Title & Document Type: **8405A Vector Voltmeter Operating and Service Manual**

Manual Part Number: **08405-90024**

Revision Date: **May 1971**

8405A

Figure 7-18(b). Schematic Diagram. Power Supplies

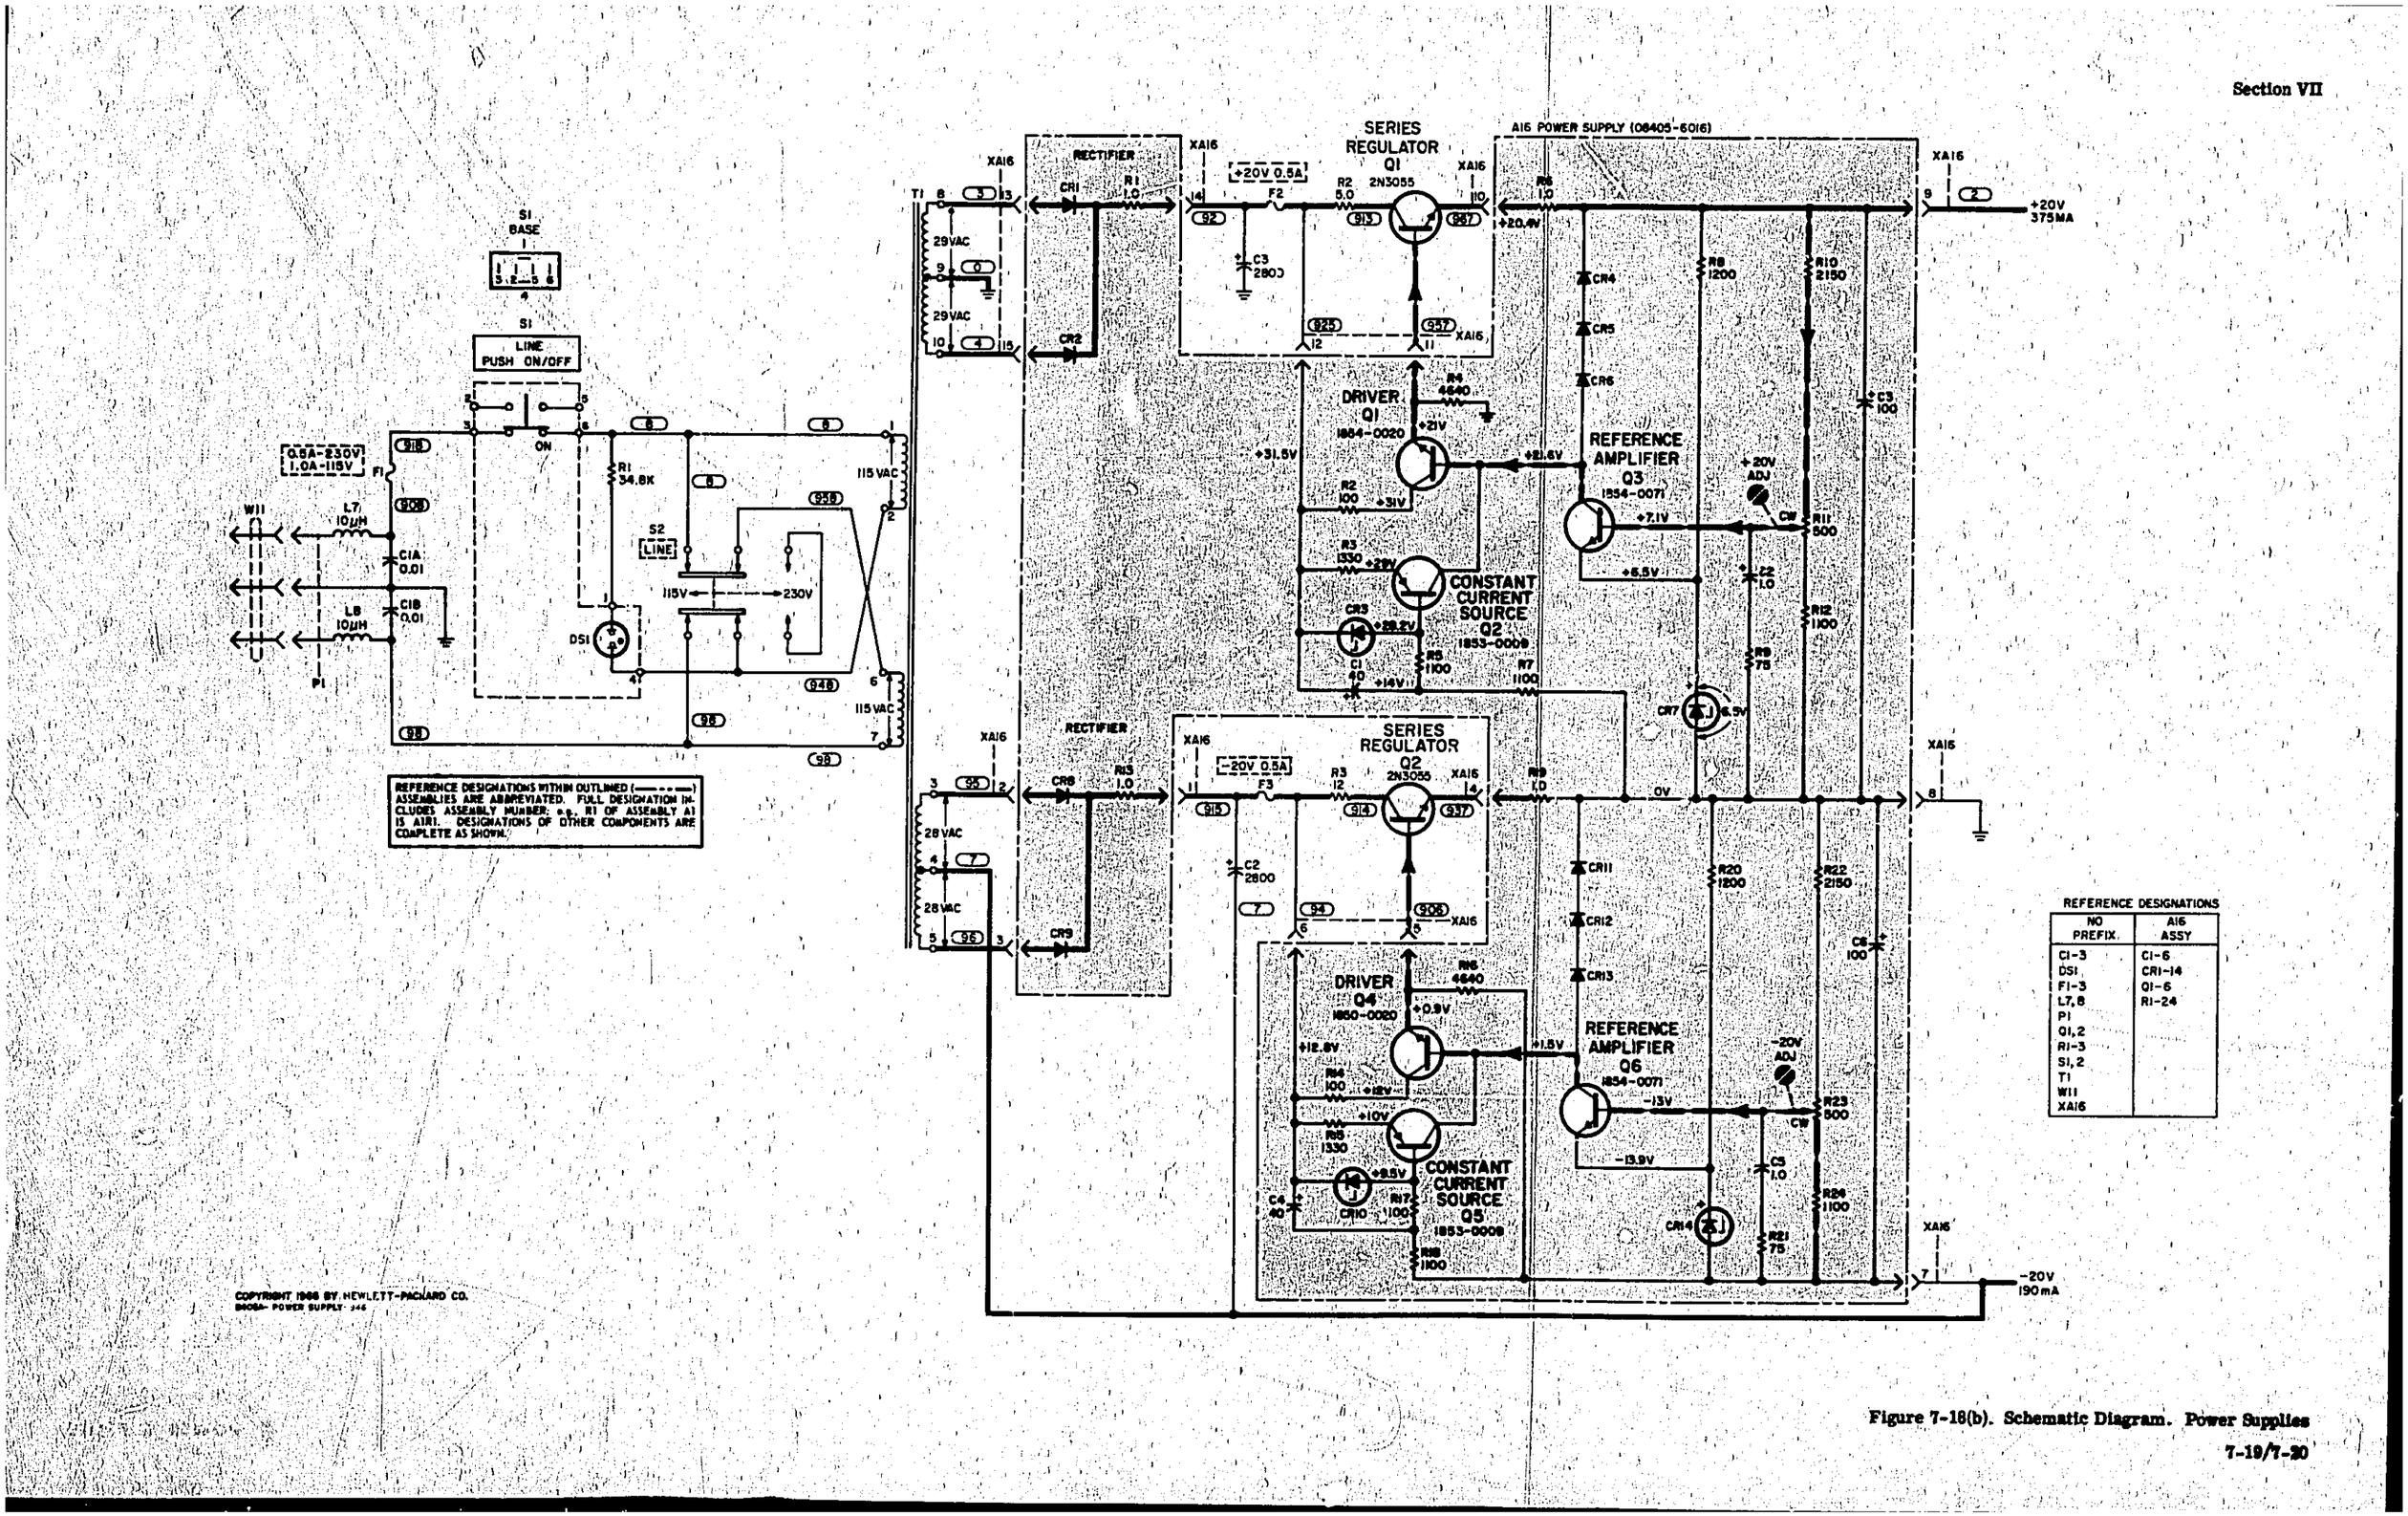
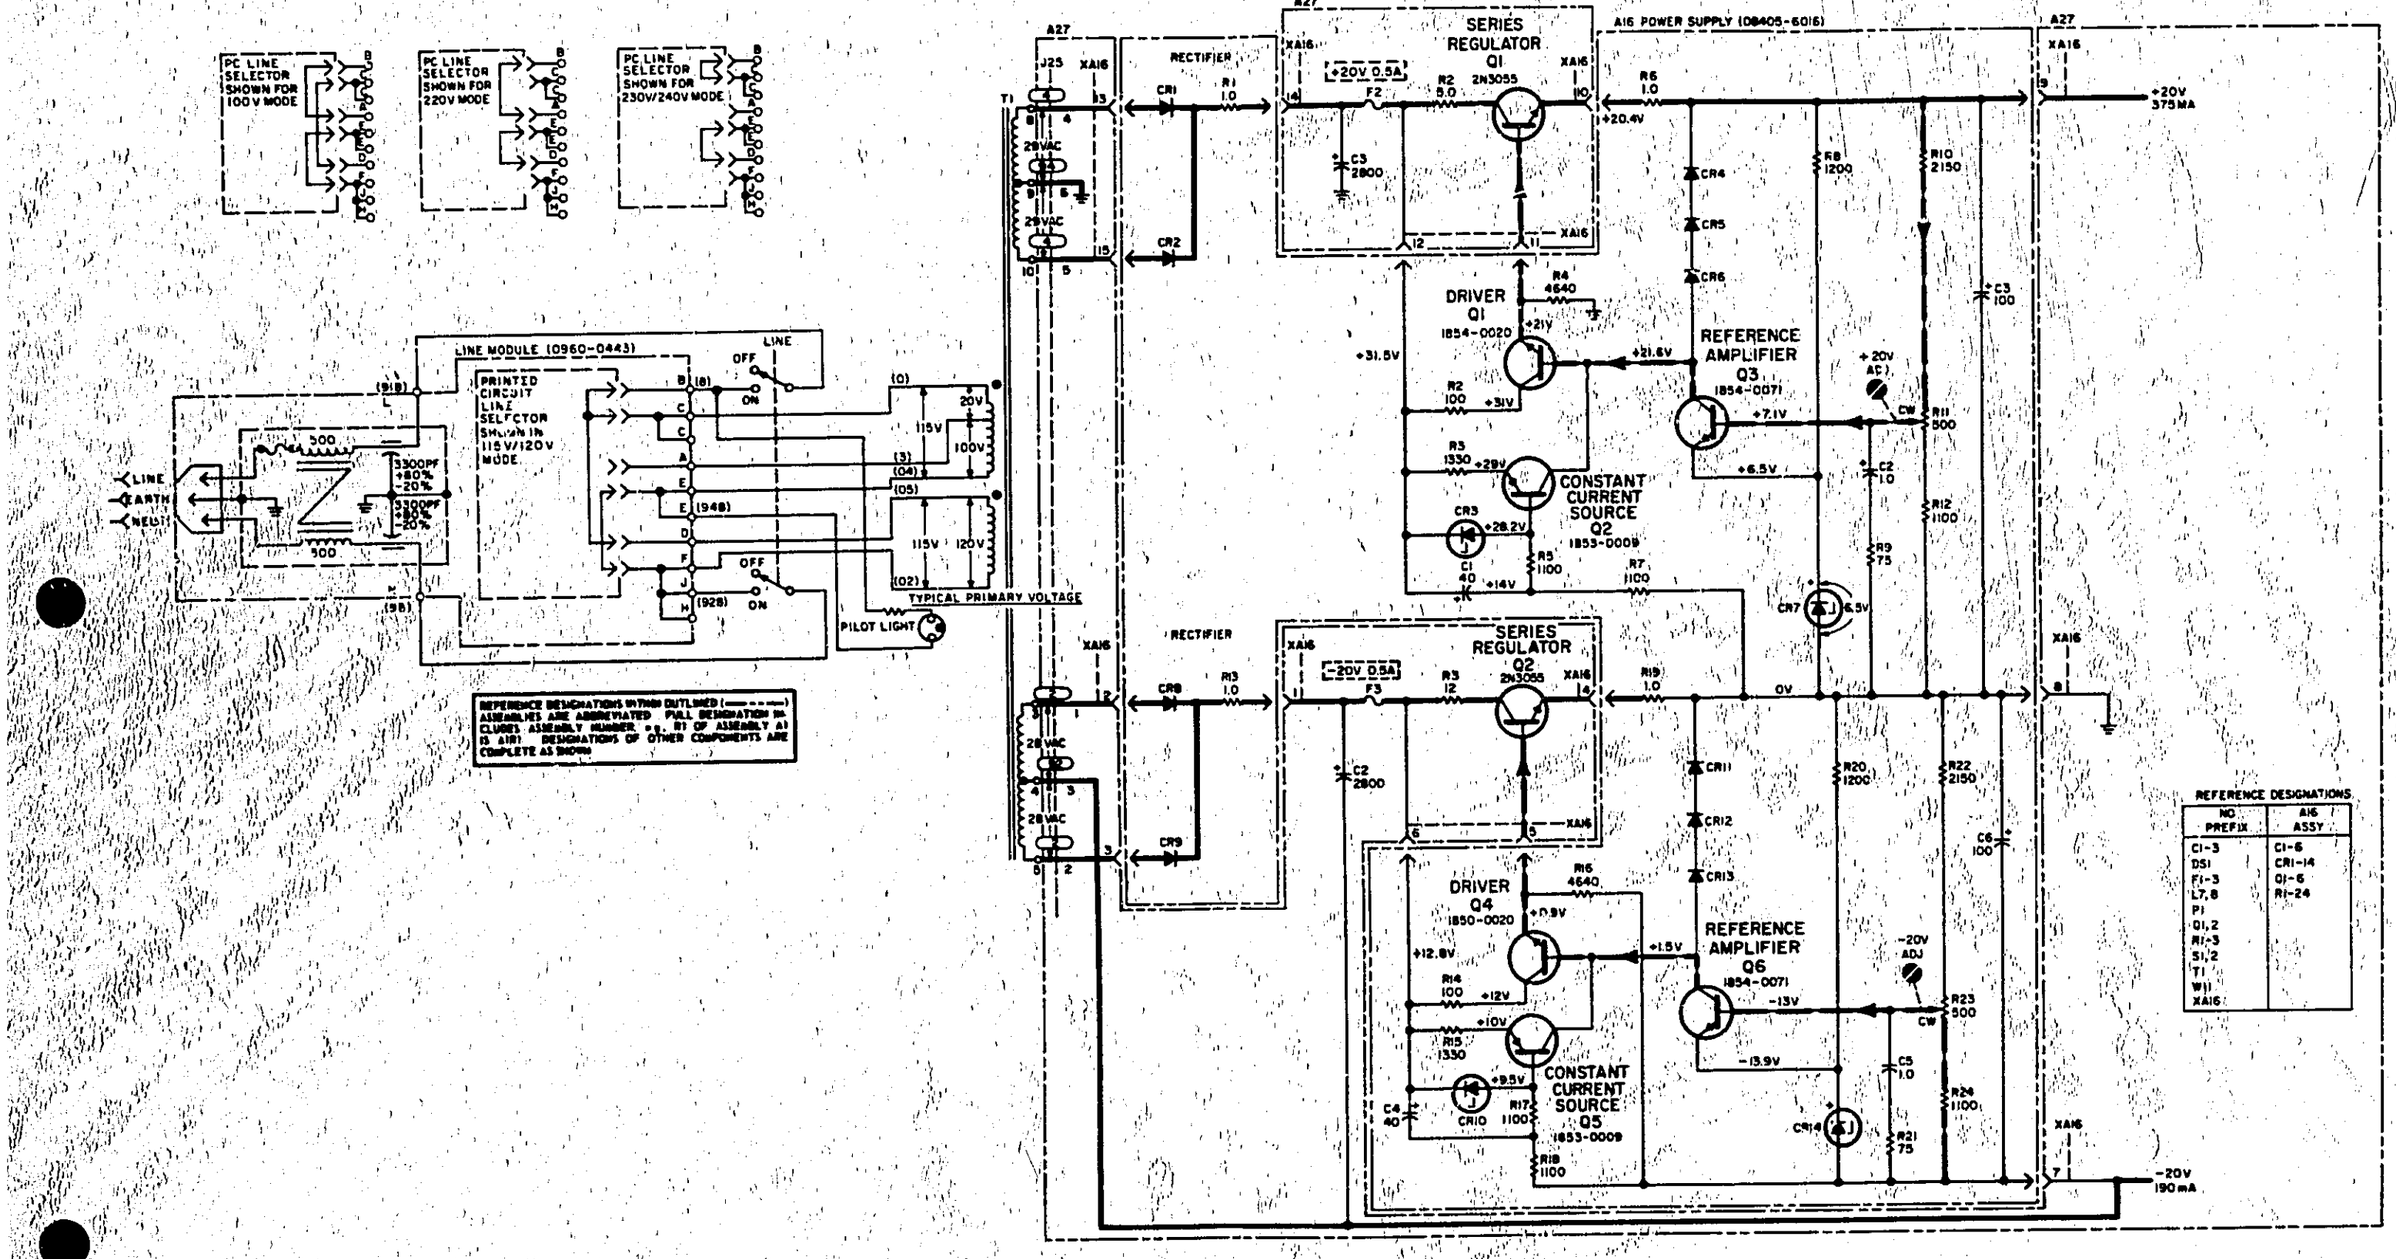
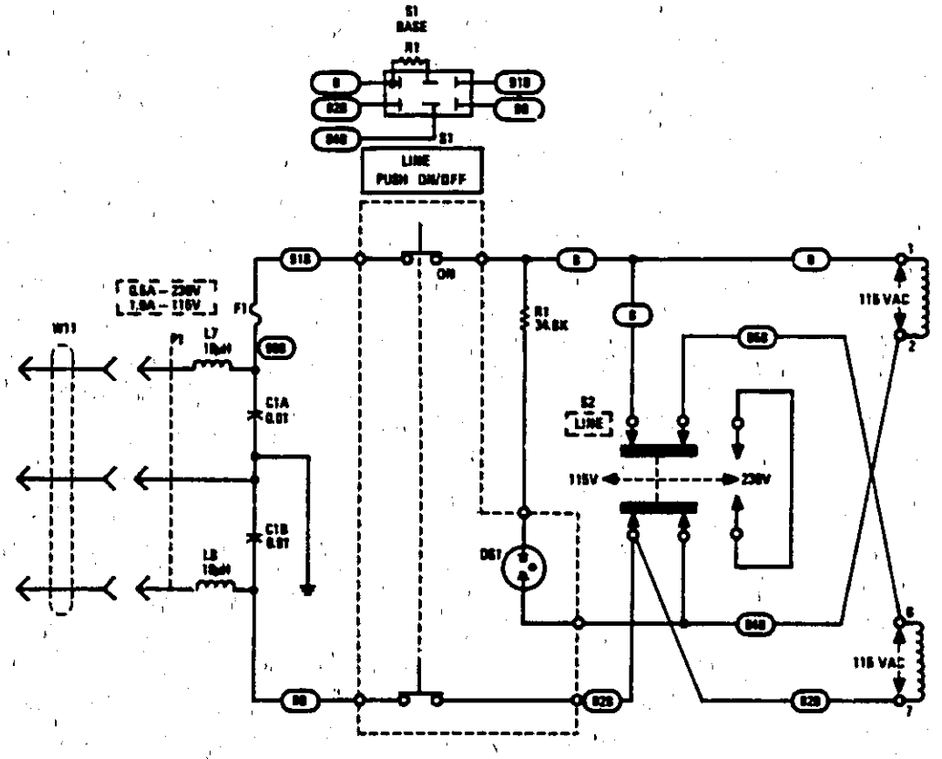
Figures 7-18(a) and 7-18(b):
Change R1 to 46.4K.

Figure 7-18(b):
Add C7. Annode to ground, cathode to base of Q5.

Figures 7-18(a) and 7-18(b):
Change primary power circuit per Figure 7-18 in this change sheet (CHANGE 7).

Figure 7-18(b):
Add A16C8, .047 uF, between anodes of CR1 and CR2.
Add A16C9, .047 uF, between anodes of CR8 and CR9.

Replace Figure 7-18(b) with Figure 7-18(b) in this document (CHANGE 17).

Figure 1. Partial Schematic of A8 Phase Meter Assy (08405-6008)

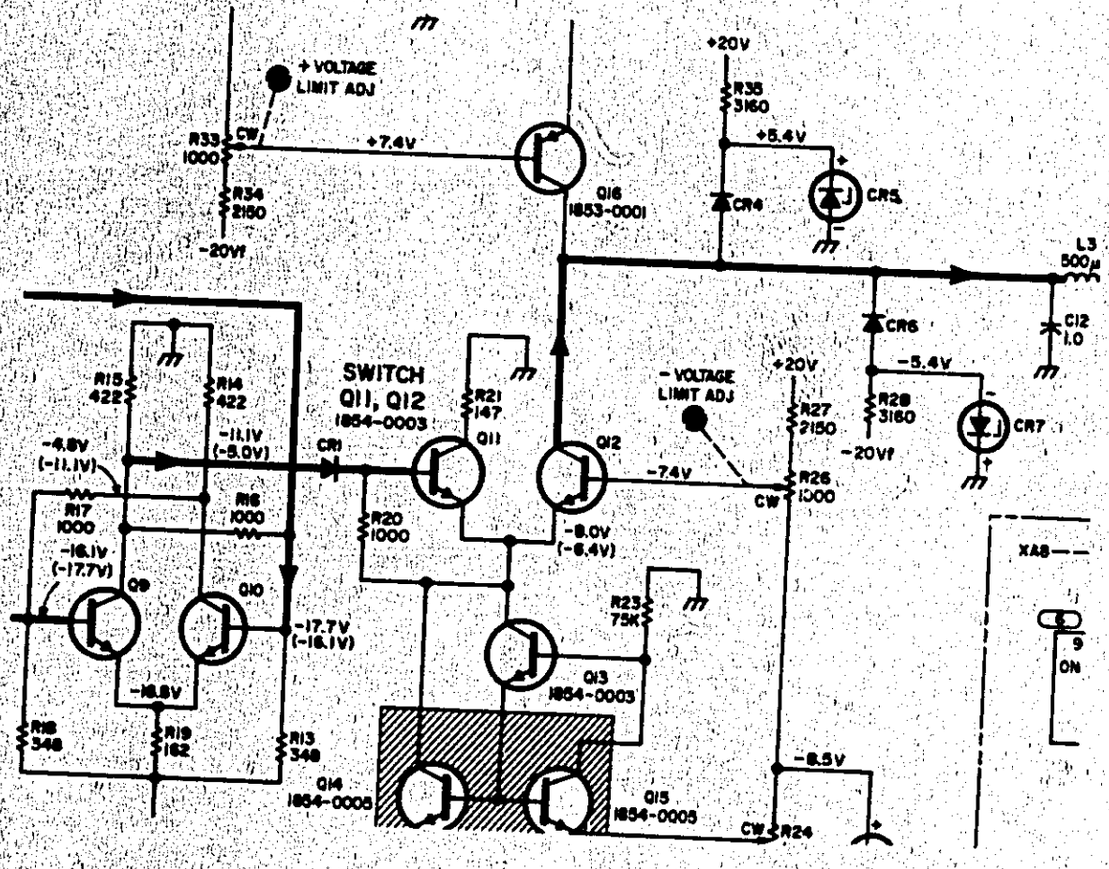
CHANGE 9: A8 Phase Meter Assy is different (see Figure 1 below) than shown in Figure 7-11.

Change Resistors A8R27, R34,

To: 0698-0084 R:FXD MET FLM 2.15K OHM 1% 1/8 W
From: 0698-3101 R:FXD MET FLM 2.87K OHM 1% 1/2 W

Figure 2. Schematic of A11 IF Sampler Assy (08405-6011)

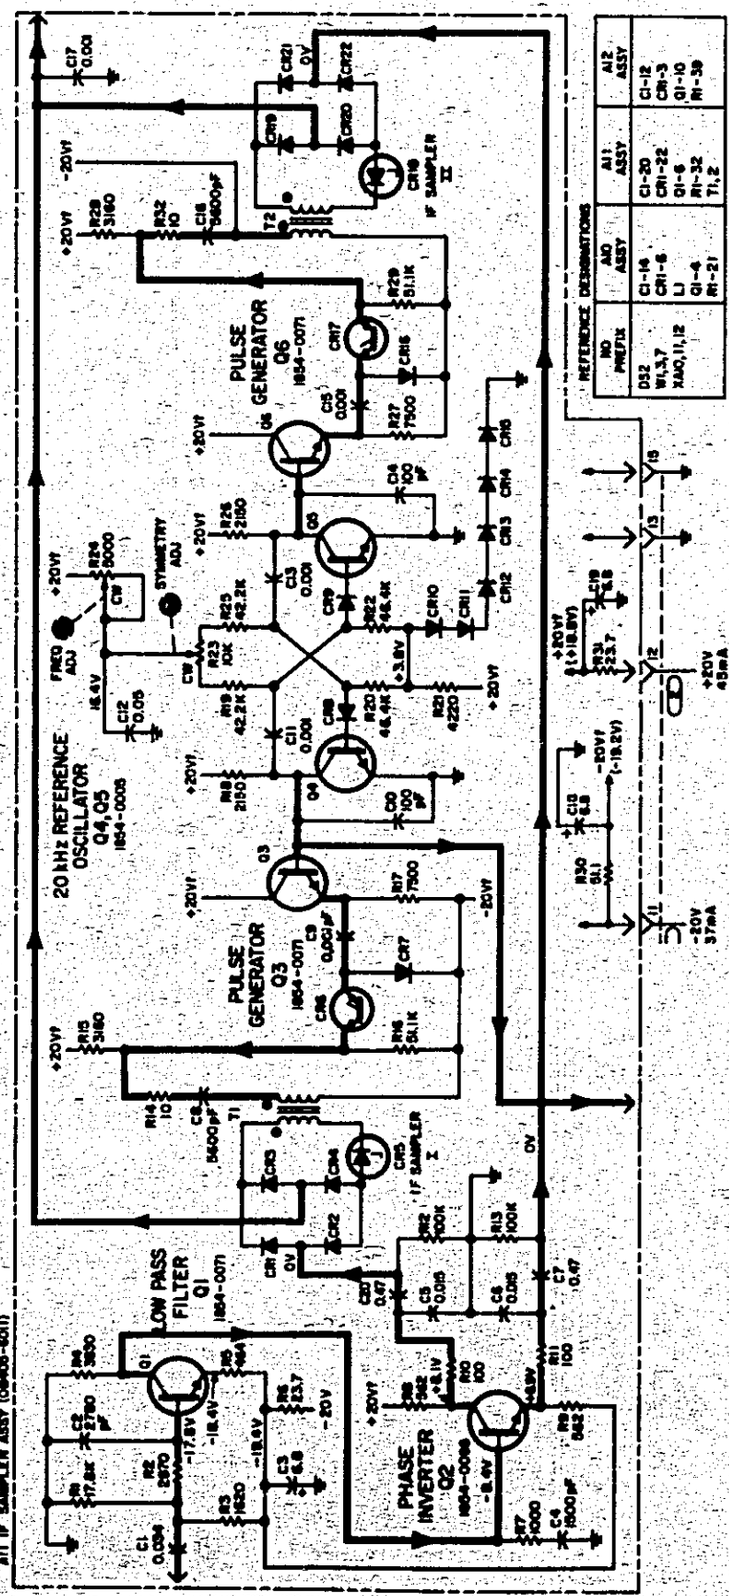
CHANGE 10: a.) A11 Sampler Assy 08405-6011 is different (see Figure 2) than shown in Figure 7-15.

Add the following:
0757-0417; R:FXD 562 OHM 1% 1/8W; TQ 2
1854-0087; Transistor NPN Silicon 2N3417; TQ1
1903-0006; Diode 4 Layer Silicon; TQ 2

b.) In the event of A12R27 failure, it is recommended that the value be changed.
From: 0698-3446 R:FXD 383OHM 1% 1/8W
To: 0686-4315 R:FXD 430Ω 5% 1/2W
